Agenda Item #1

Application 2025-29-CA

2308 Ashland Place Avenue

Construct new single-family residence with attached garage

1 ELEVATION
SCALE: 1/4"=1'-0"

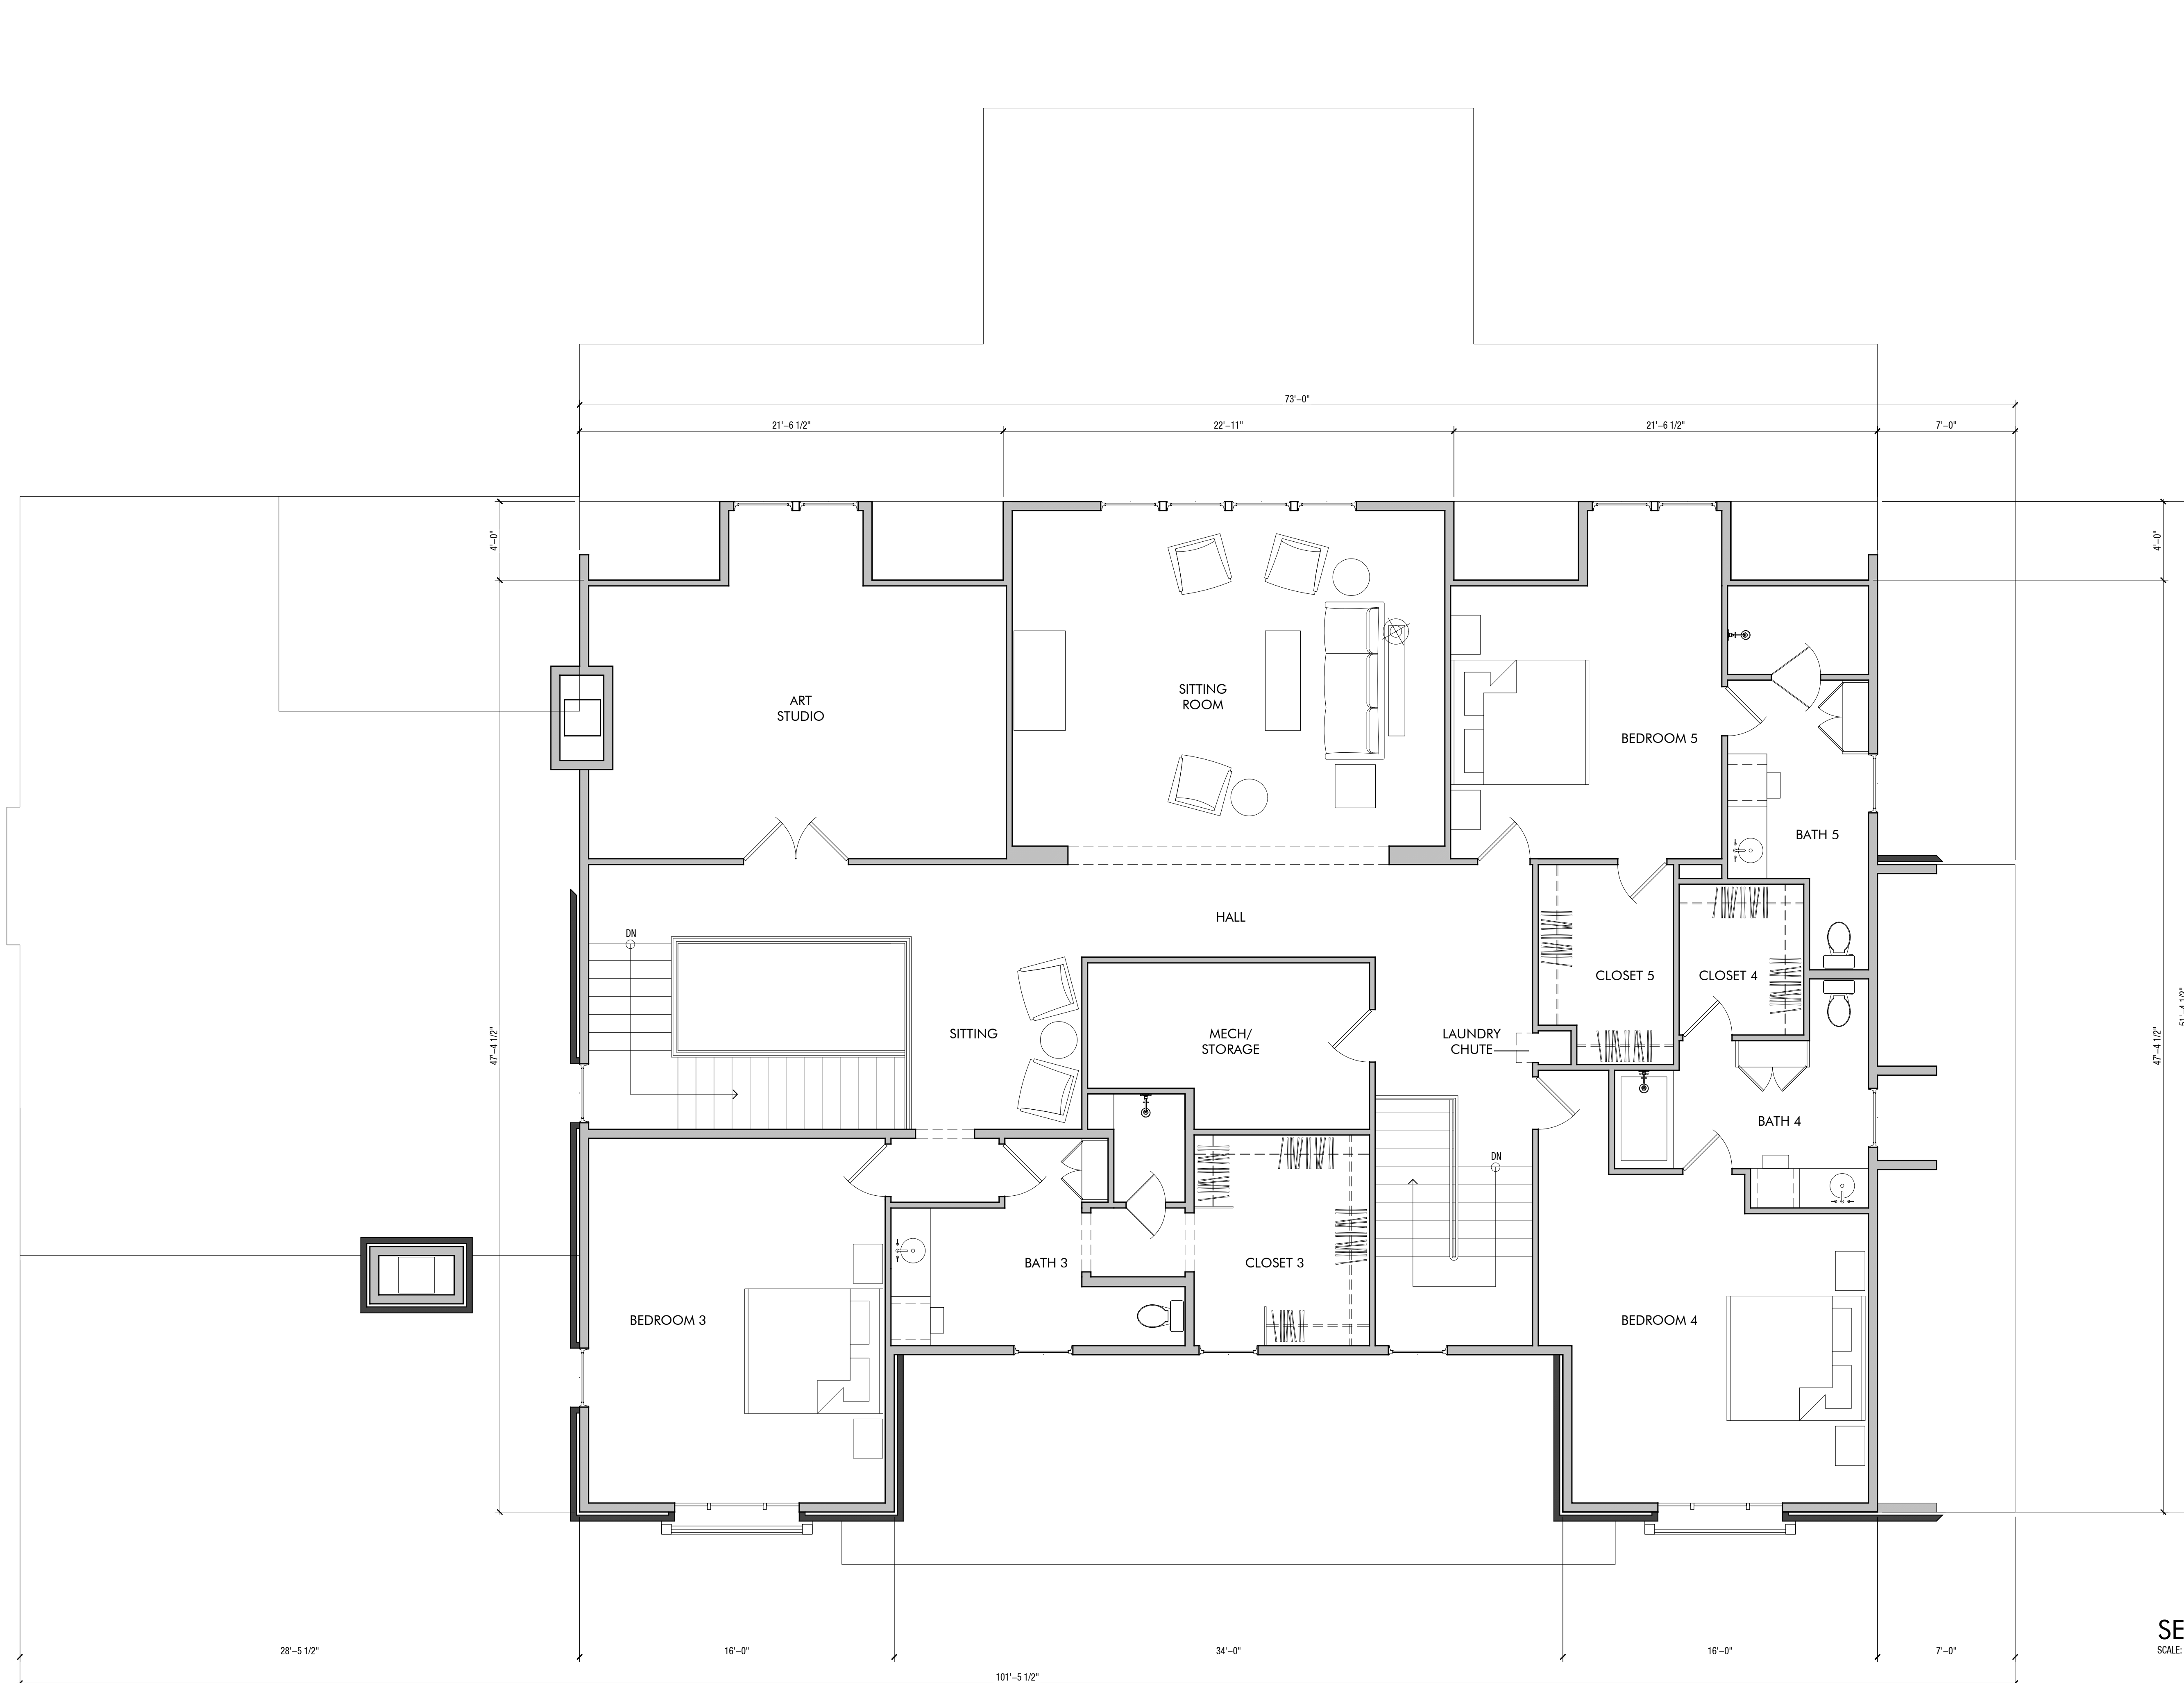
2. There is a chimney shown on Elevation 1 that does not appear on Elevations 2 or 4. For now, I'm assuming that 2 and 4 are correct. Is that what was intended?

5. On the floor plans, the exterior window/door configurations shown in the kitchen, living room, primary bedroom, bedroom 3, and bedroom 4 do not match what is shown on Elevations 4 and 2. Are the plans correct, or the elevations?

See revised exterior elevations.

See revised plans and elevations.
